FINAL EIR
CHULA VISTA BAYFRONT
REDEVELOPMENT PROJECT
Adopted by
Chula Vista Planning Commission
June 22, 1977

EIR-77-4

Chula Vista Redevelopment Agency
276 Fourth Avenue
Chula Vista, California 92010

WESTEC Services, Inc.
1520 State Street
San Diego, California 92101

FIGURE 2-5

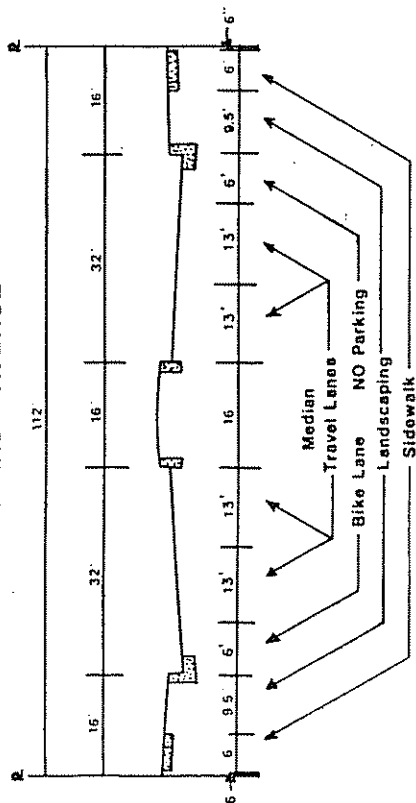
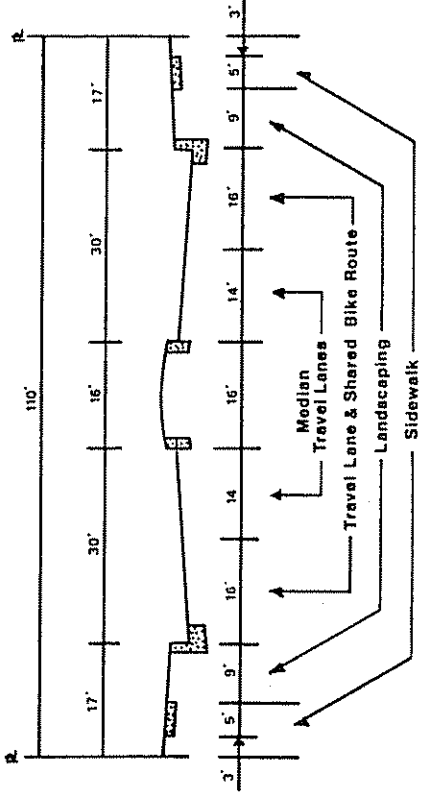
Figure 2-5, Schematic Street Sections - The diagram of "Tidelands Avenue through marsh" indicates that there will be both an 8-foot bike lane and a 10-foot bike path along the roadway. In addition there will be a 16-foot median as well as a 9-foot landscaping strip.

Figure 2.5 Schematic of Street Sections

In response to this comment and other input the proposed typical section for this portion of Tidelands Avenue has been revised to reflect the minimum facility we believe to be appropriate for the uses expected to ultimately occur at this location. A modified figure 2.5 is submitted herewith for substitution in this EIR.

FIGURE 2-11 PROPOSED ENHANCEMENT / BUFFER AREAS

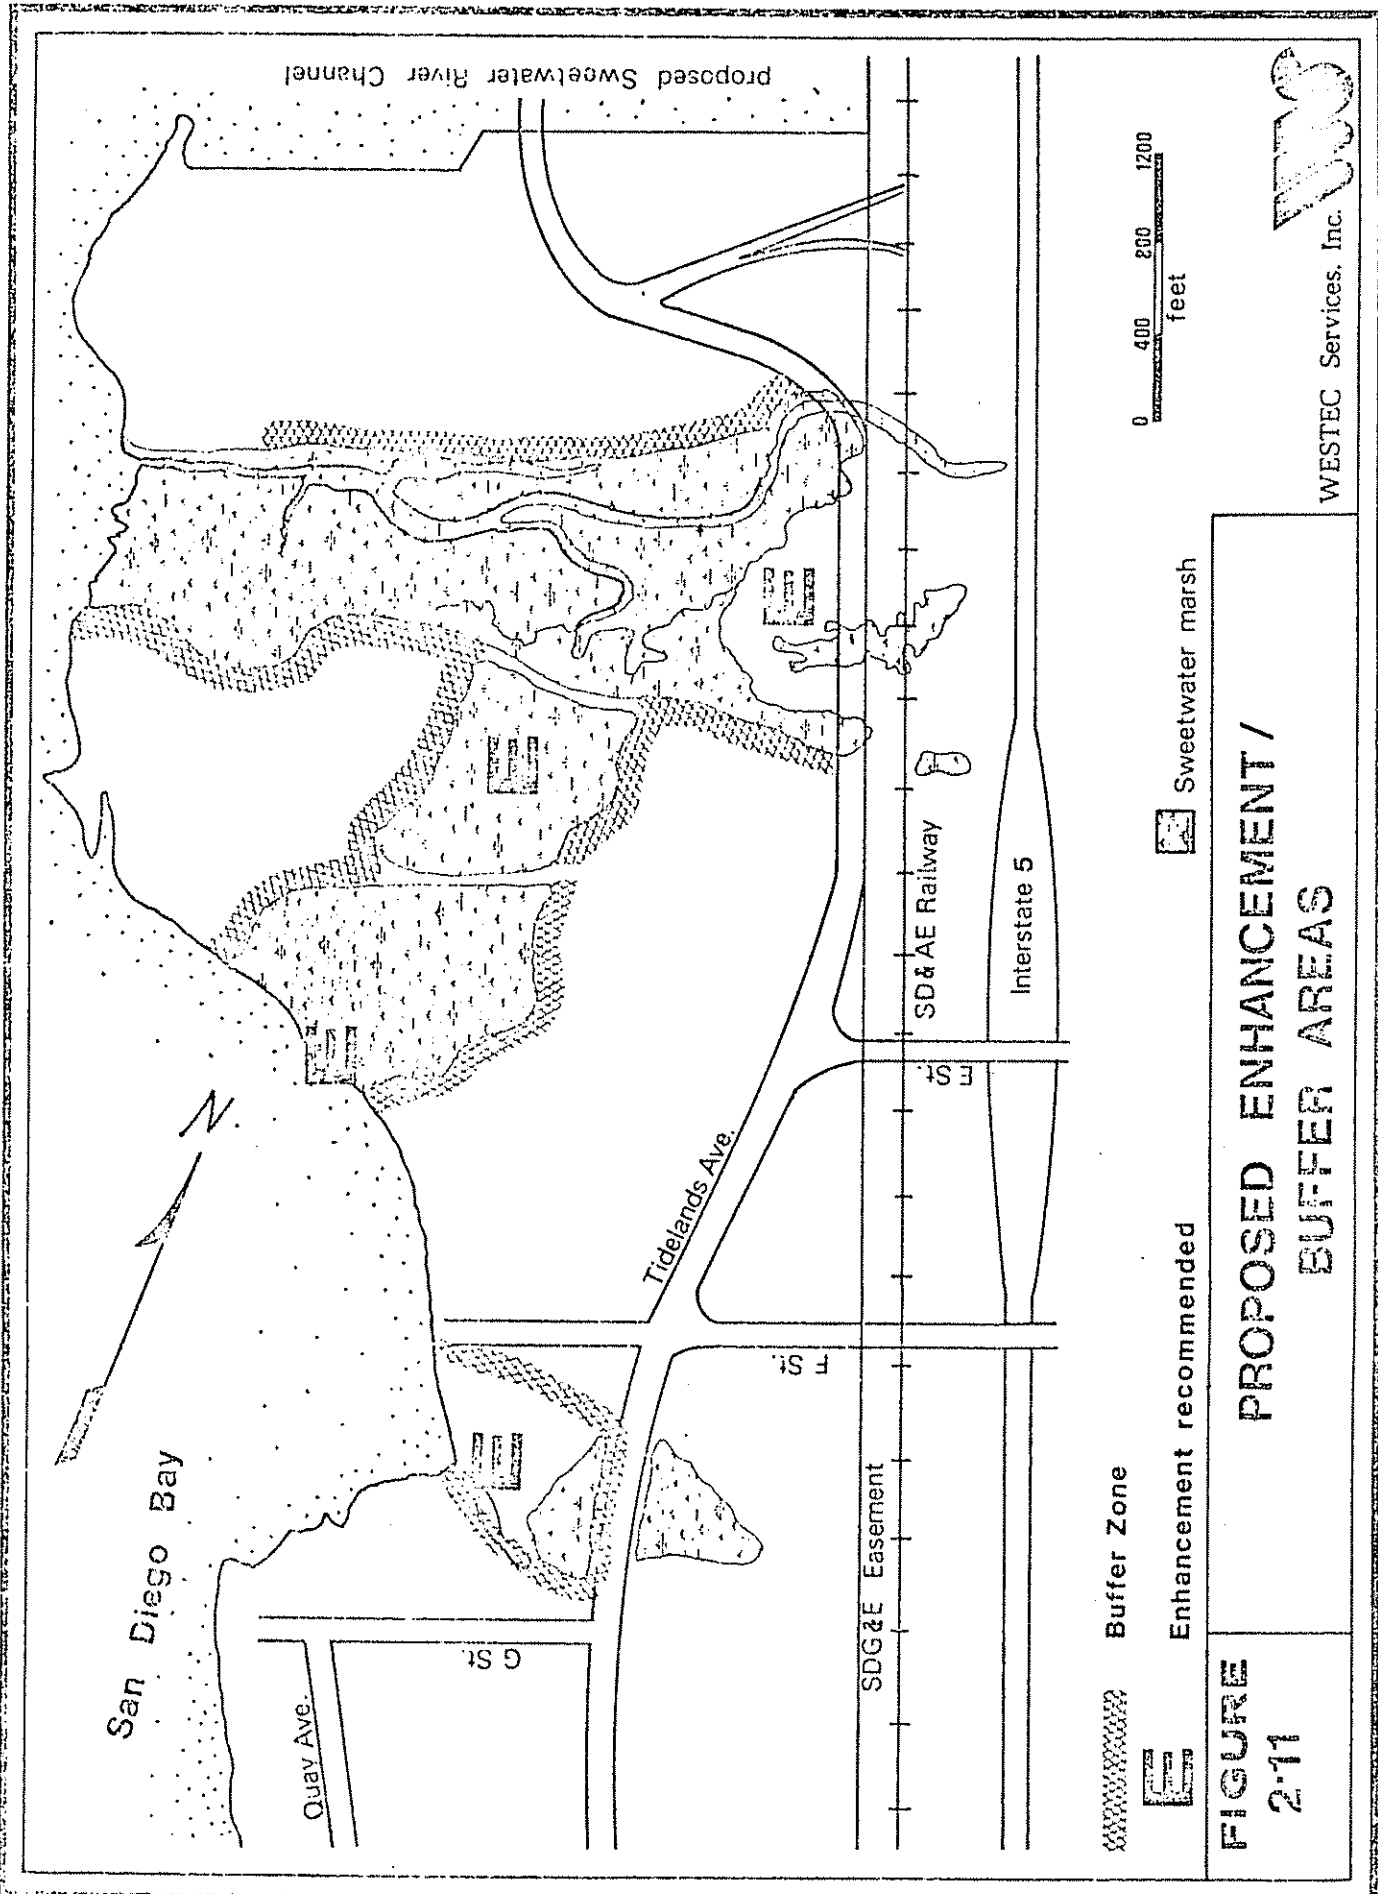
Page 27, Figure 2.11

FIGURE 2-12

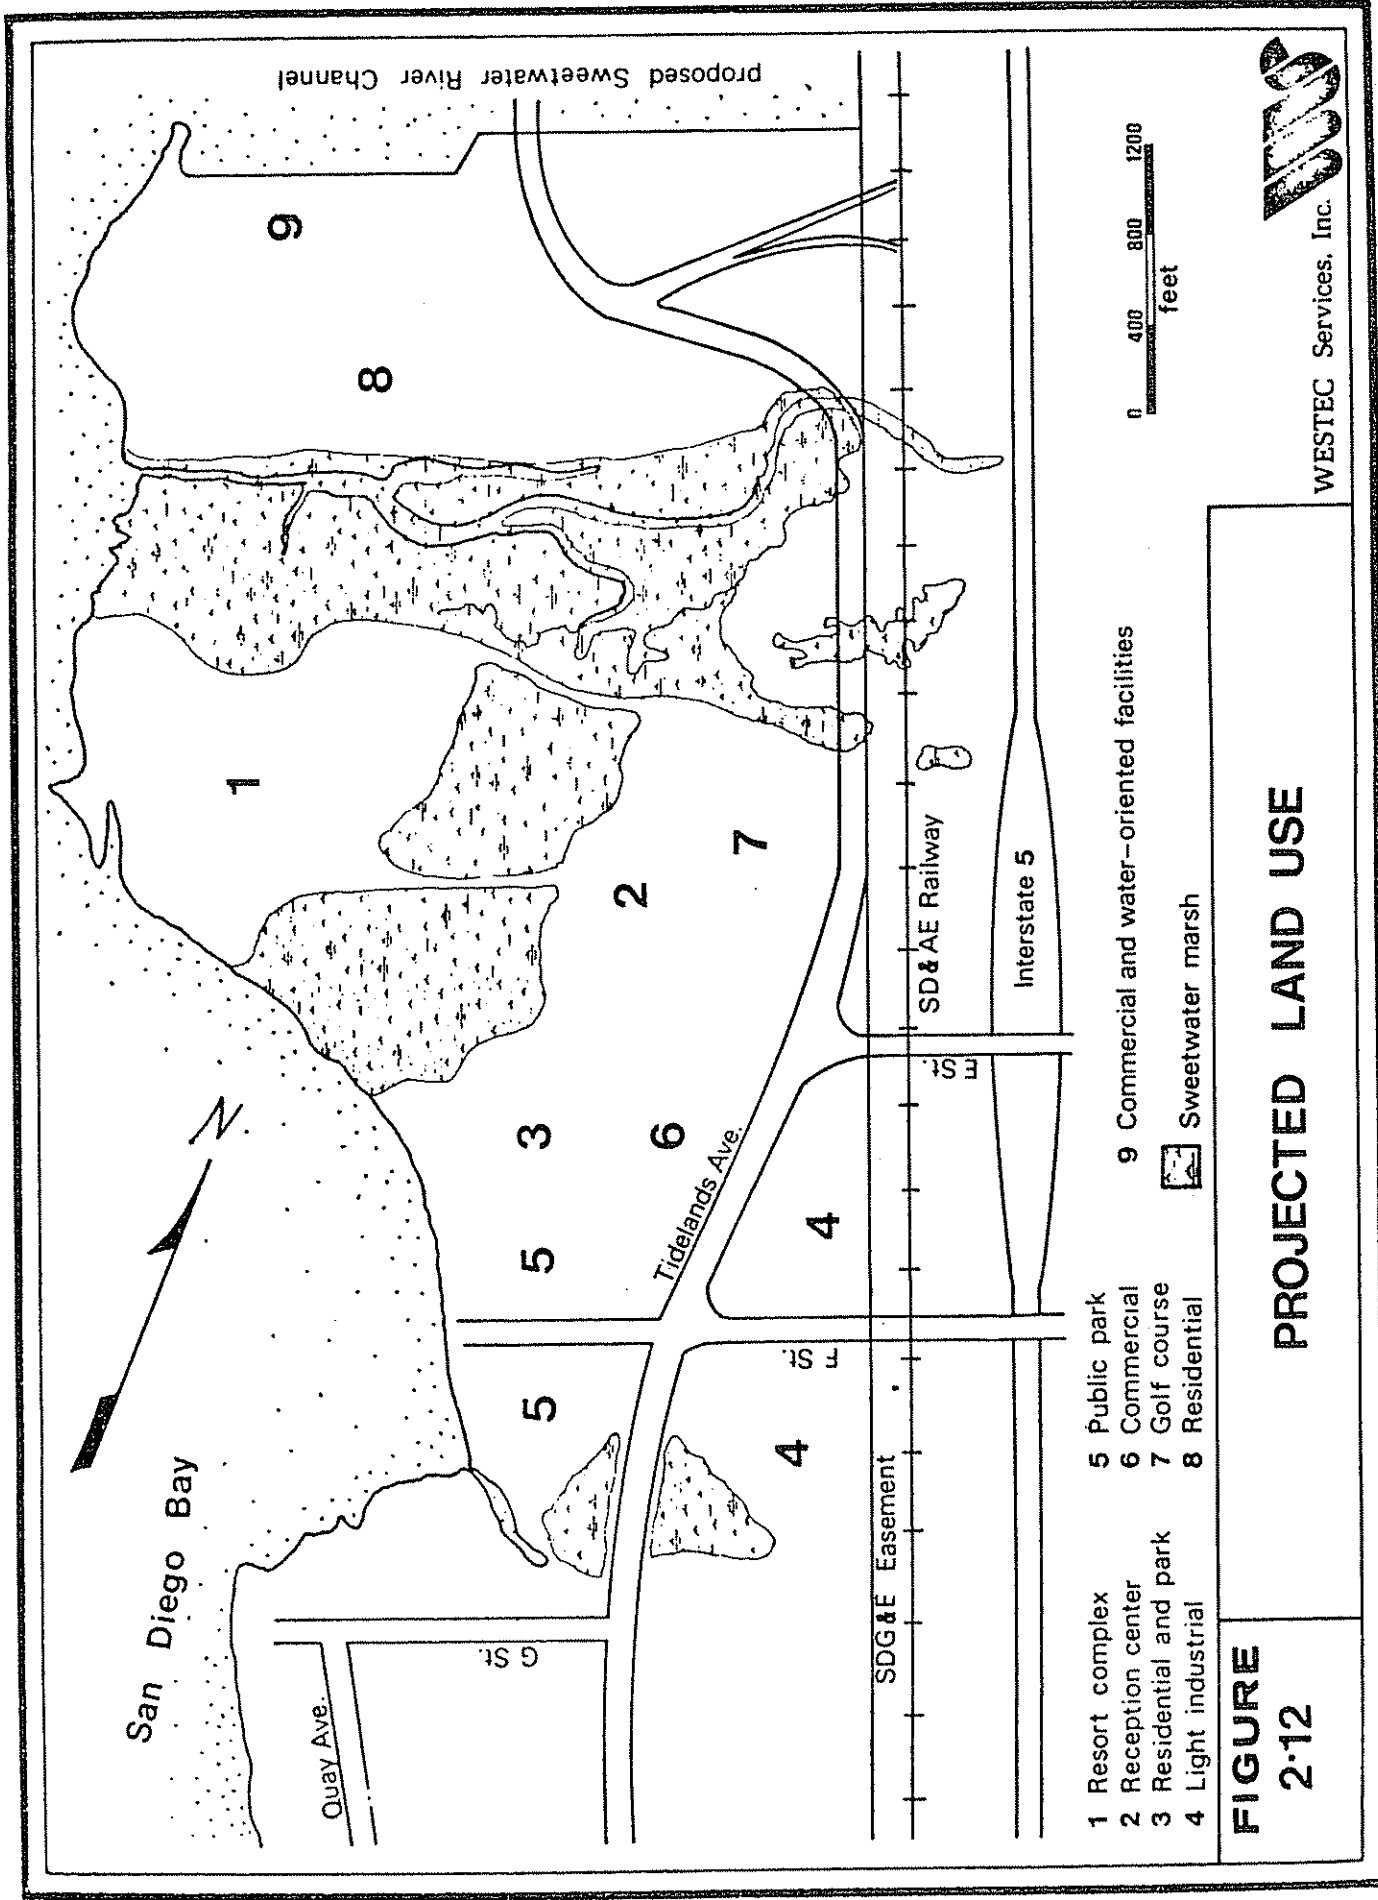
Figure 2-12, Projected Land Use - This diagram should clearly indicate that the toe of the D-Street fill is not included under the "Commercial and Water Oriented Facilities" designation. That portion of the land fill as well as the adjacent mud flats would require preservation because of their inherent environmental values.

Figure 2.12 Projected land use
